ADDENDUM TO SOLICITATION/OFFER AND AWARD

1. ADDENDUM 1	2. EFFECTIVE DATE 5/23/17	3. SOLICITATION NUMBER RFQ 17-4	4. SOLICITATION DESCRIPTION Levy Kitchen Equipment
5. ISSUED BY: Steward E. Trautman, Jr., Director of Purchasing Founders Hall / Room 109 3001 SW College Road Ocala, FL 34424 TELEPHONE: (352) 854-2322 ext. 1227 FAX: (352) 291-4423		6. MAIL TO: COMPANY NAME: CONTACT: COMPANY ADDRESS: TELEPHONE:

<p>1. Questions and responses is attached regarding specifications.</p> <p>2. Drawing of work tables is attached.</p>

BUILD
First
3
A330
1/4" = 1'

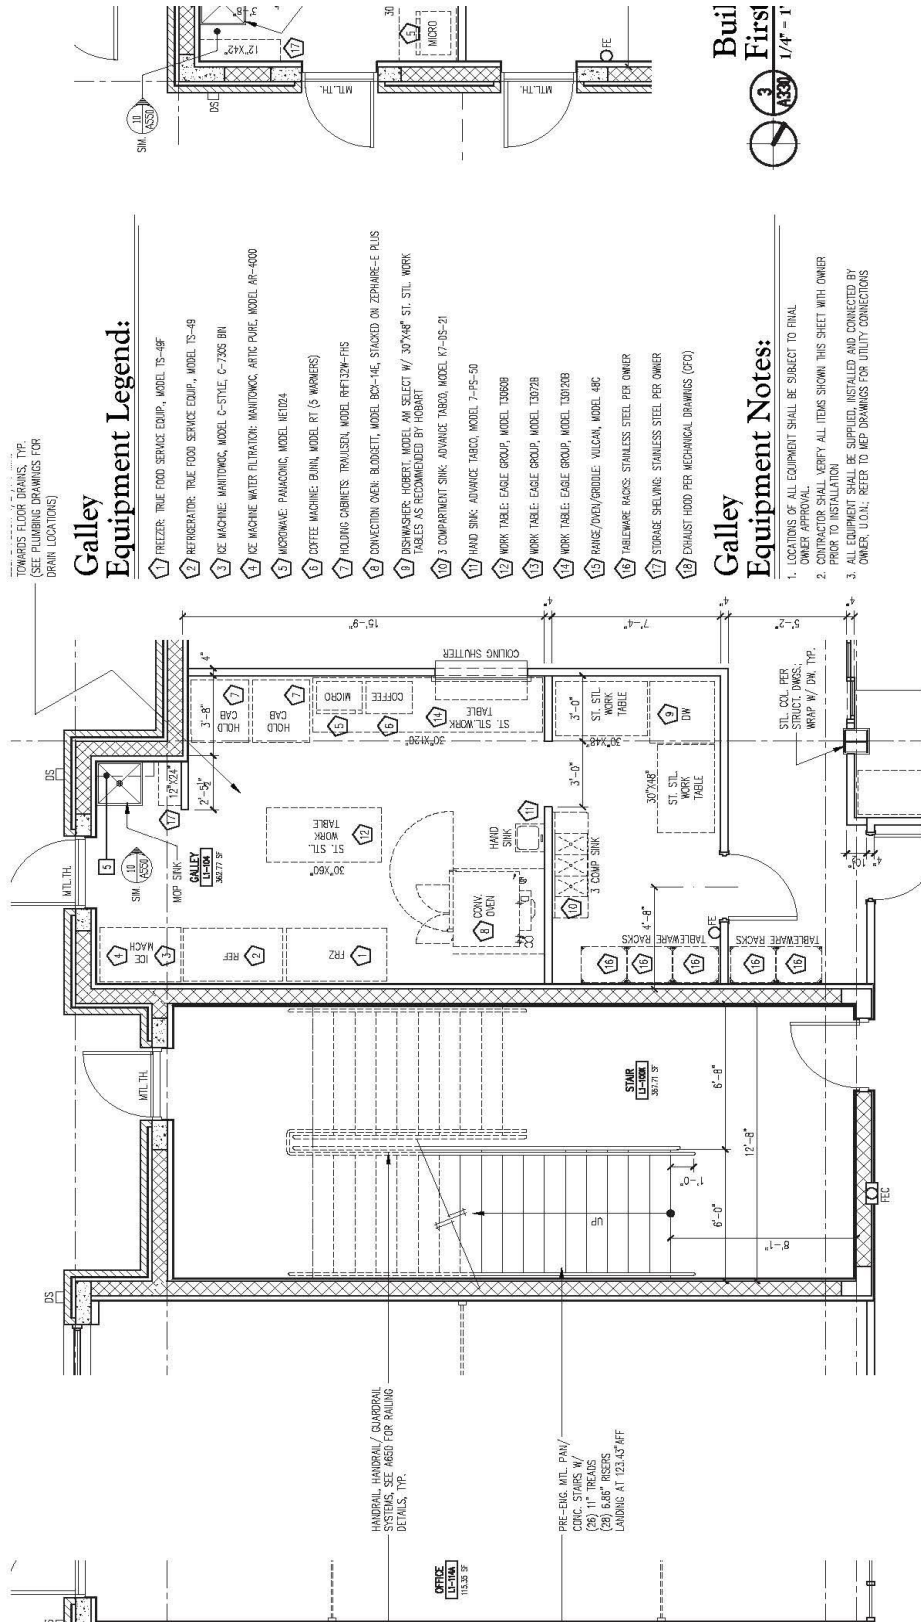
Q - Hobart: With or without booster heater? Gas or electric heat (electric is standard)? Voltage? Suggested water hammer arrestor kit? Tables: With or without back splash -if with - splash height. Undershelf? Legs/undershelf galvanized or stainless?

Q - Eagle: Just confirming that you want galvanized undershelf and legs vs stainless.

R - Tables: With or without back splash -if with - splash height. **Yes, 6" back splash**

R - Undershelf? **Yes**

R - Legs/undershelf galvanized or stainless? **Stainless Steel**

R – **Stainless Steel**
